# Access Compliance Report

## Public Rights-of-Way

### (Pedestrian Signals)

Intersection ID: N/A	Main Street:	Cross Street: N/A	Location: N/A
ADA ID: 12D2BB00536F	Signal Type: One Push Button-Non APS	Overall Compliance: No	Severity Score: BTN 1: N/A BTN 2: N/A No BTN: N/A
Codes/Mitigation Info/Possible Solution		Field Measurements/Component Compliance

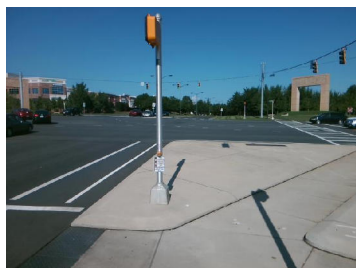
Possible Solutions: Replace Signal Push Button With APS Button. Provide Clear Space.

PROW/ADA: R404.1, R404.7.1, R404.7.2, R104.2, R209.1
